Figure 2.4.3-1. Hourly Distribution of the Probable Maximum Precipitation for the Swan Creek Watershed

Figure 2.5.1-1 Fermi 3 Site Regional Physiographic Map
(Reproduced from Fermi 3 COL FSAR Figure 2.5.1-202)

Figure 2.5.2-12 Comparisons of the Staff's Site Response Amplification Functions with the Amplification Functions Determined by the Applicant

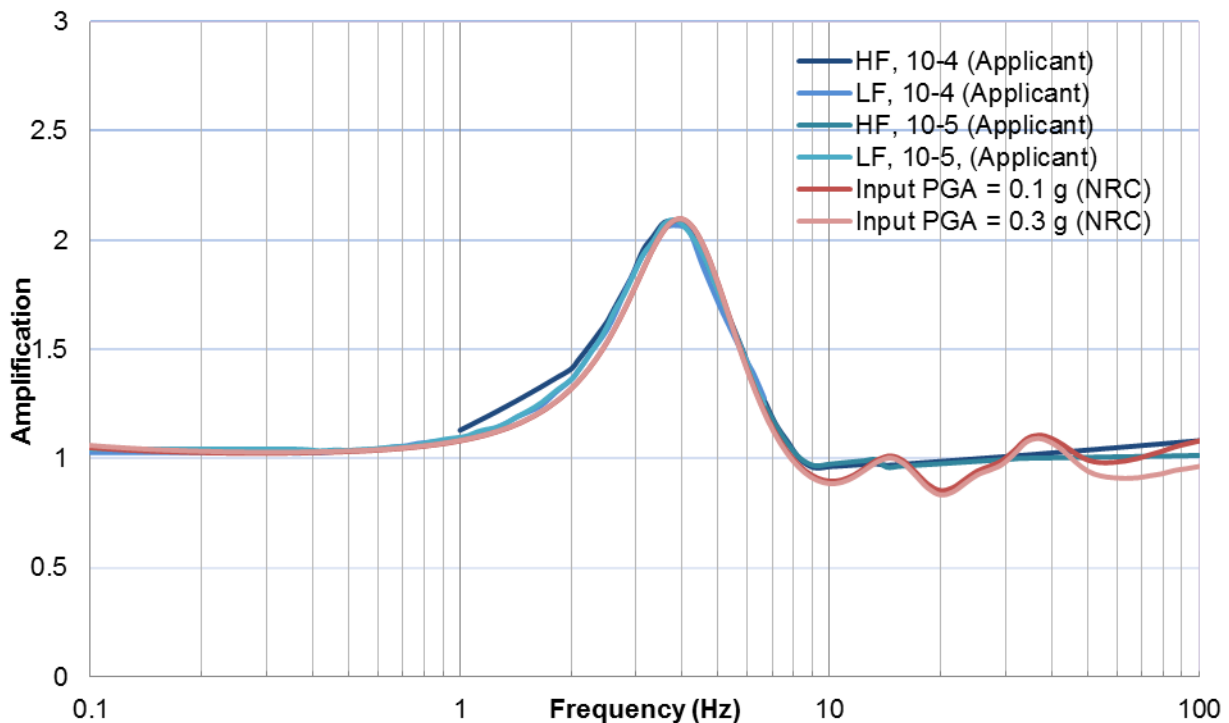
To determine the adequacy of the applicant's site response calculations, the staff performed confirmatory site response calculations. As input, the staff used the static and dynamic soil properties in FSAR Section 2.5.4 and summarized in FSAR Table 2.5.2-213. The staff performed site response calculations using the RVT methodology with 7 spectral frequencies and 11 input rock amplitudes. The use of RVT in site response calculations is mentioned in RG 1.208 as an acceptable alternative to the time series approach. The staff's site amplification function results are compared with the applicant's results in Figure 2.5.2-12 in this SER.

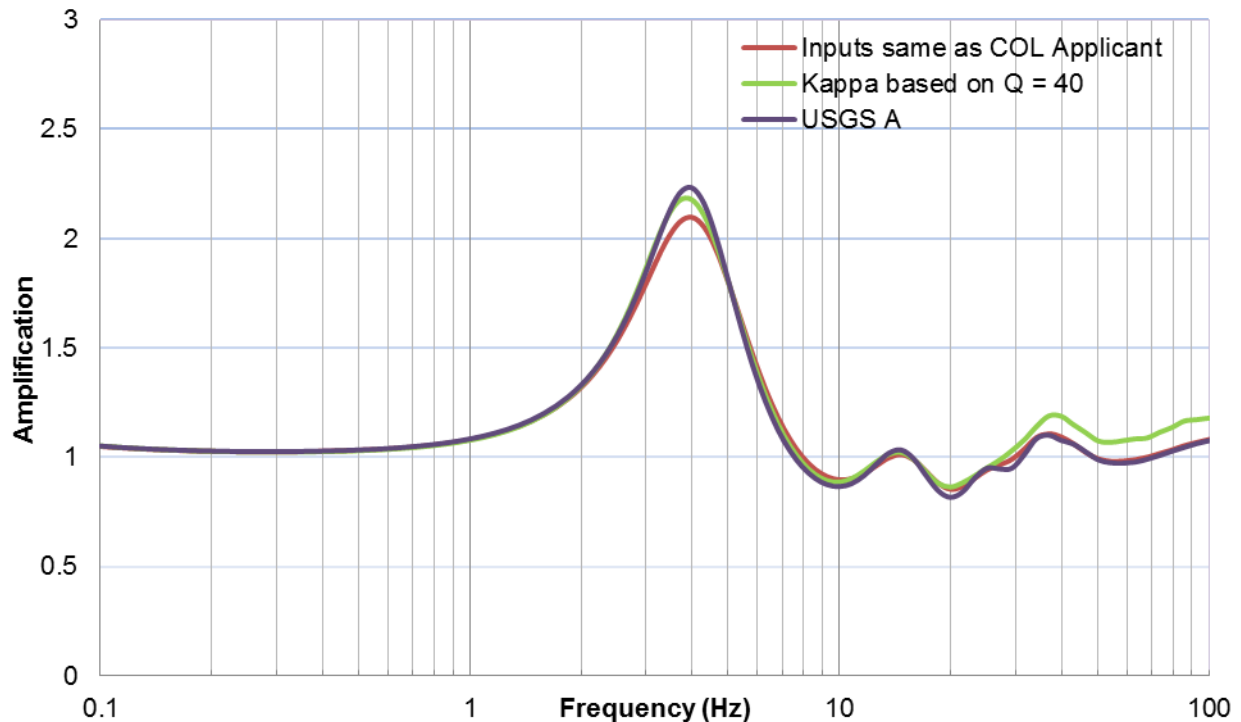
Based on the above assessment, the staff concludes that the applicant's site response calculations adequately characterize the Fermi 3 site effects.
